SB, Overheating issue upgrade kit, CRT 60, 2022-12

CRT 60 has been reported to overheat in numerous cases. Investigations found several possible reasons for such failure and upgrade kit 546006801 has been introduced.

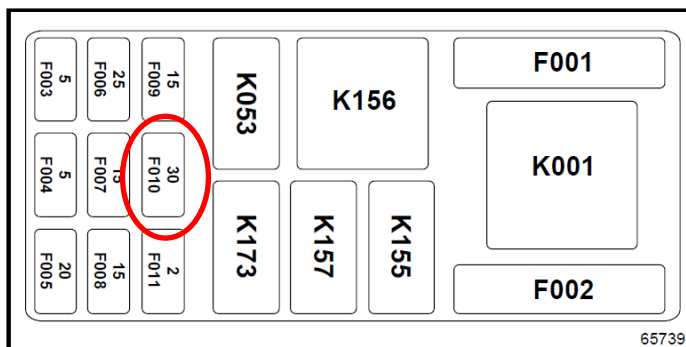
- Change the engine coolant overflow bottle cap seal 599064501. Use the one from the upgrade kit 546006801. Secure the inner hose with a zip-tie.

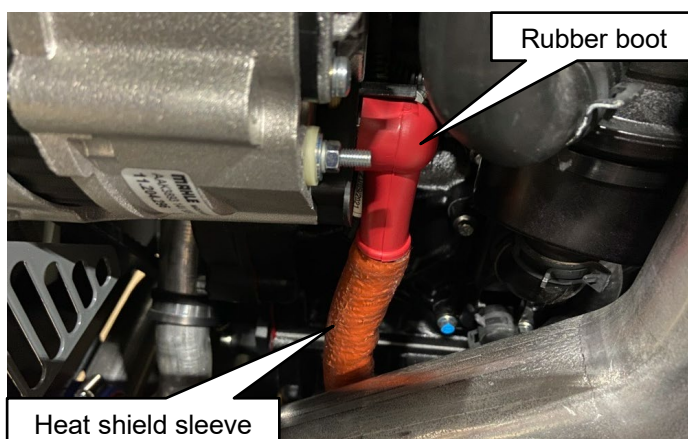
- Change the hydraulic oil cooler fan fuse. Use 535612501 from the upgrade kit 546006801.

Appendix A

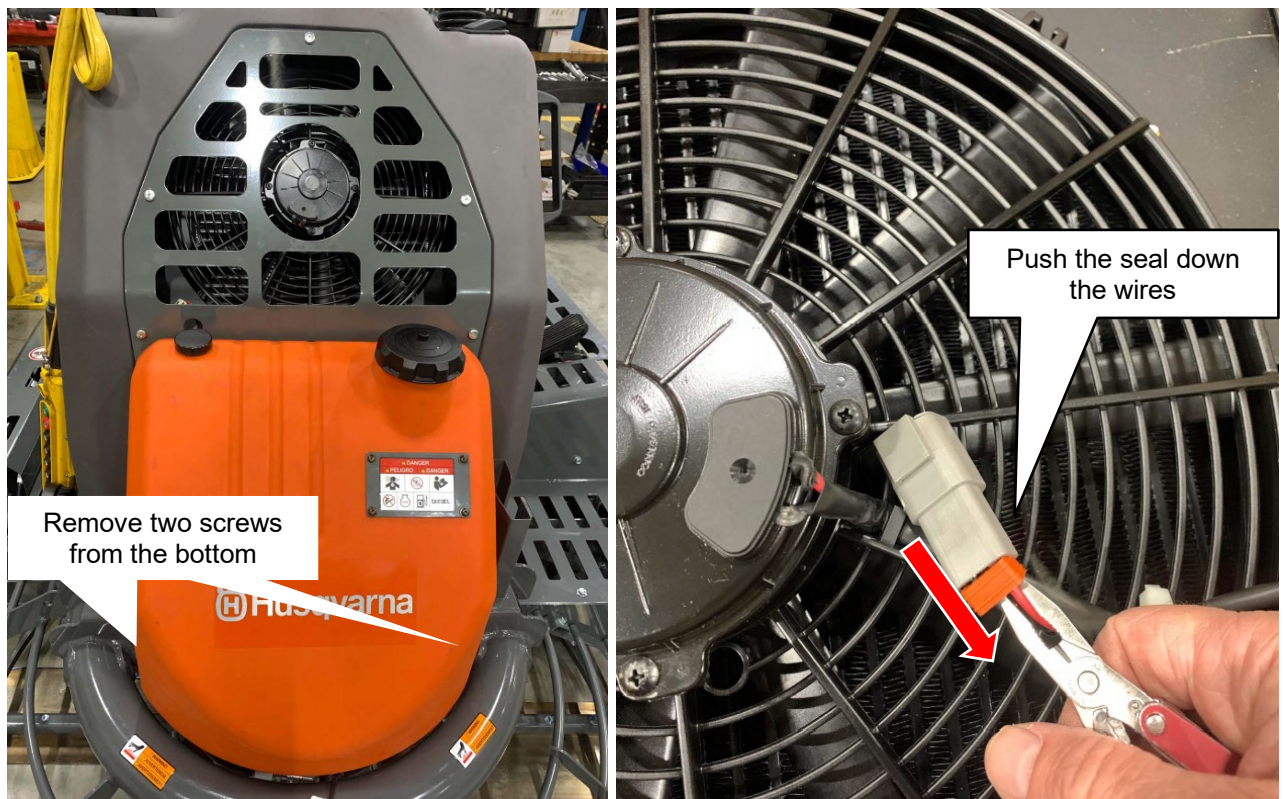
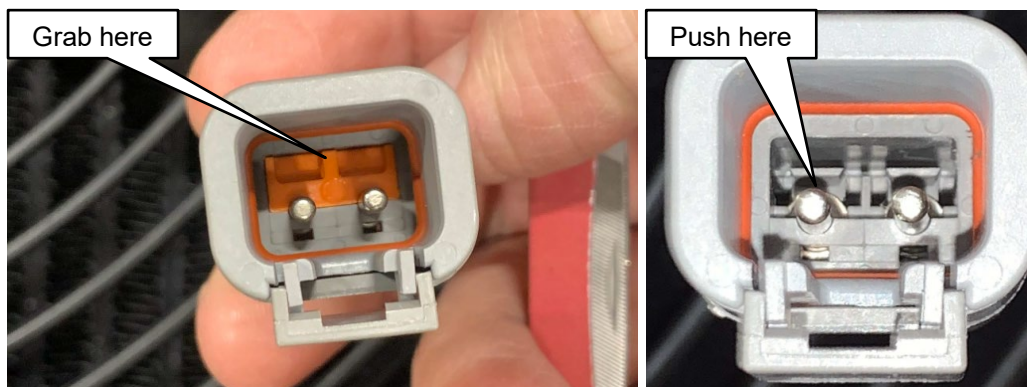
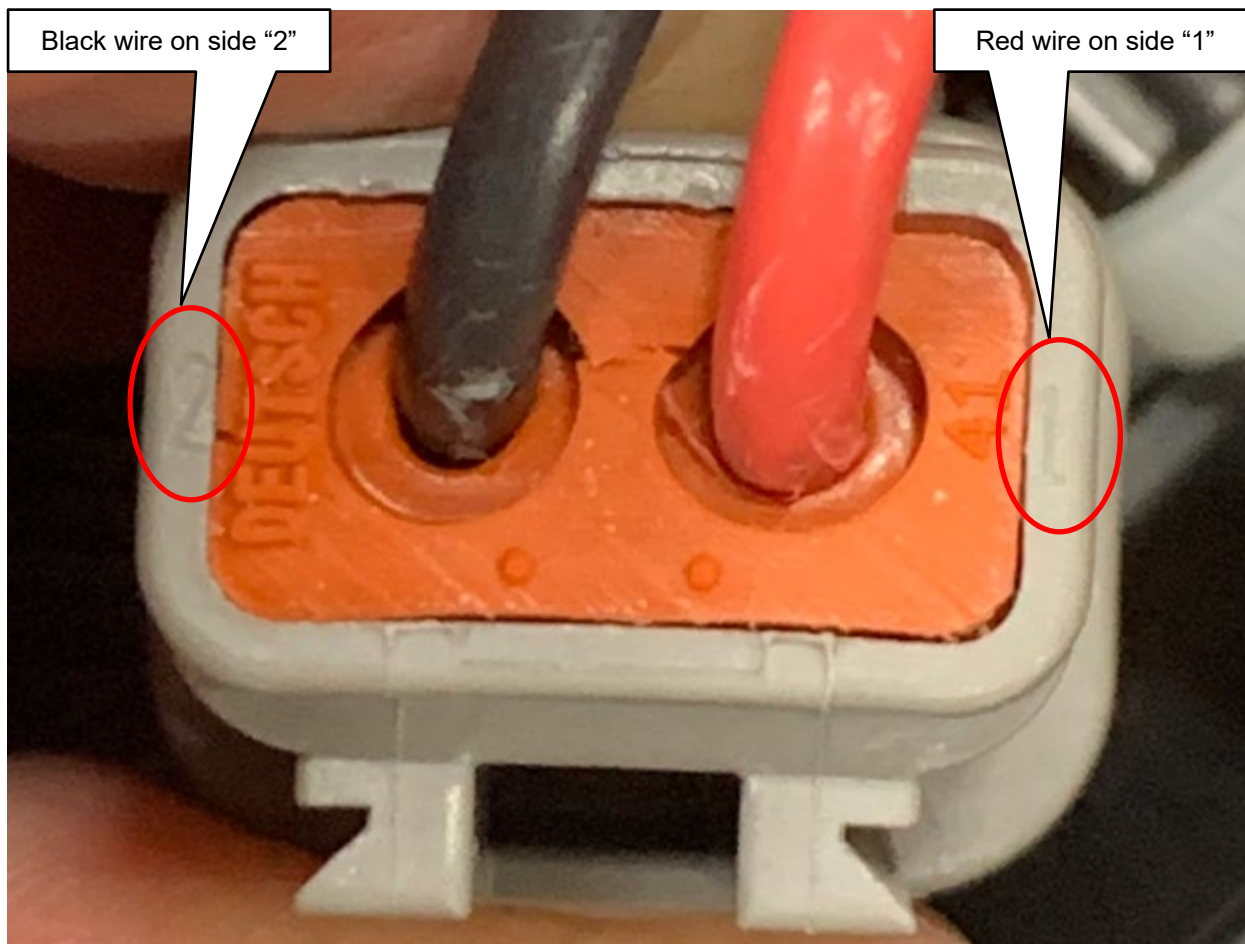
- Order upgrade kit 546006801.
- Check if the hydraulic oil cooler fan blows air towards the cooler. Follow *Appendix A* to change the direction of rotation if needed.
- Check for correct routing of the hydraulic fan wire harness. Follow *Appendix B* to change the routing of the wire harness if needed.
- Check for presence of insulations surrounding the hydraulic oil cooler fan, #303 and #304. If a piece of insulation is missing, take it from upgrade kit 546006801.

1. Remove the fuel tank by removing the two screws from the underside. Remove the fan guard.

2. Remove the back seal of the connector and push it down the wires.
3. Grab the center bar of the orange wedge with needle nose pliers and remove it.

4. Push the pin lock and pull the pin out of the socket.

5. Reinstall the wedge after placing the pins in correct holes and push back the seal.

6. Red wire should be on side "1" of the connector, black one should be on side "2".
7. Reconnect the fan. The red and black wires should align with the same color wires on the main harness.
8. Reinstall the fan guard and the fuel tank.

Appendix B

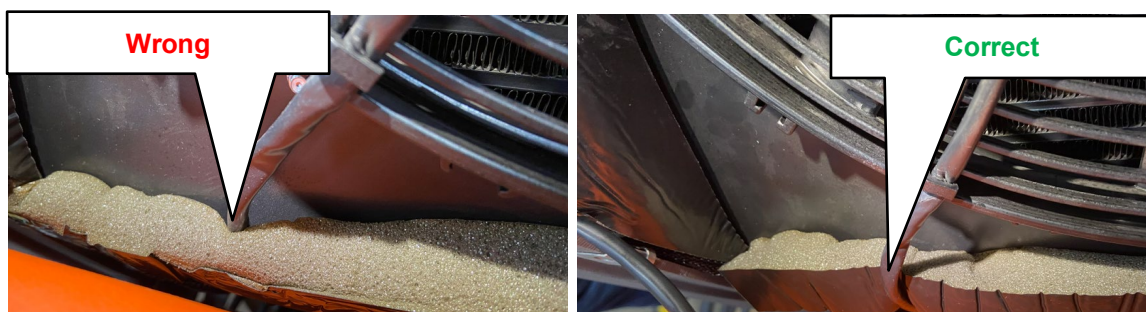
2. Check for the correct routing of the hydraulic fan wire harness. It should be between the insulation and the cooler cage. If not remove the insulation and place a new piece of 599083101 from the upgrade kit 546006801.

Appendix C

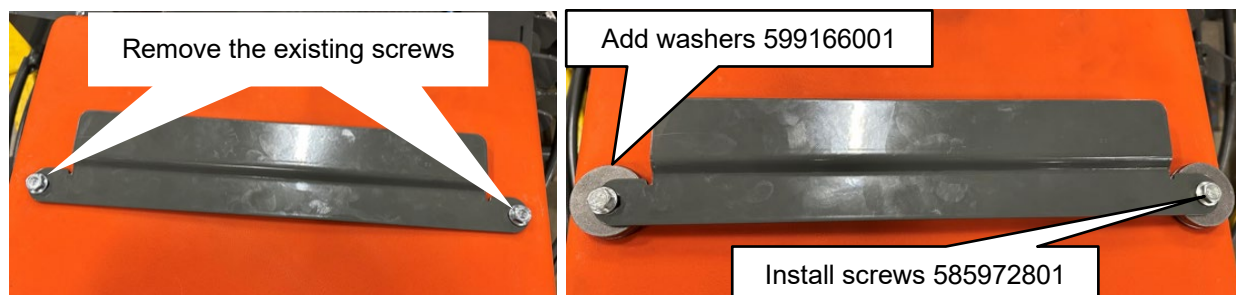
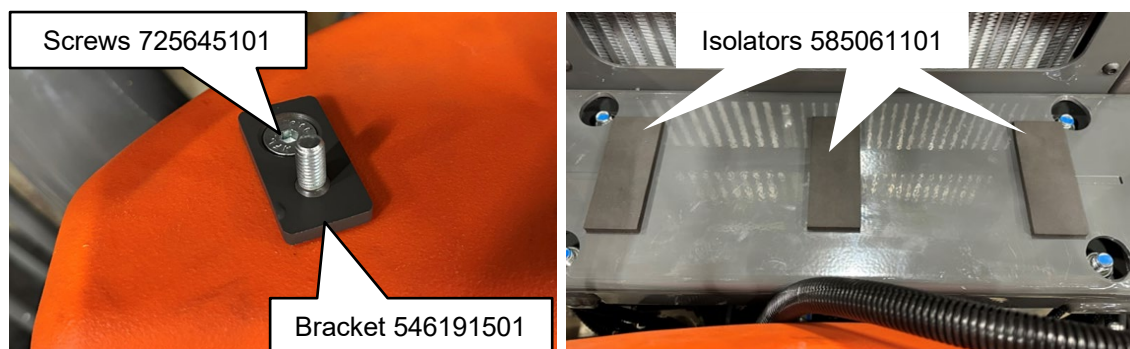
- Reposition the water tank using the parts from upgrade kit 546006801. Follow *Appendix C*.

1. Remove the two screws from the underside of the water tank using a 13 mm socket with extension and lift the tank off the frame.

2. Remove and discard the two M8 screws securing the bracket to the tank using a 13mm tool.
3. Install four washers 599166001 from kit 546006801 between the water tank and the bracket and secure with two screws M8x30 585972801 using a 13mm tool.

4. Attach the two brackets 546191501 to the bottom of the water tank with two screws 725645101. Leave them snug but still able to move.

5. Install three 585061101 isolators onto the frame 127mm/5" apart starting from center.
6. Reroute the LED light wire harness to run under the frame.

7. With the bottom brackets snug installed, set the tank in place and align the bottom brackets to the frame bracket. Once the correct position is identified, tighten the bottom brackets to the water tank using 5mm Allen key.
8. Hook the tank onto the frame and secure it to the frame bracket with two nuts 732251801 using a 13mm socket with extension.
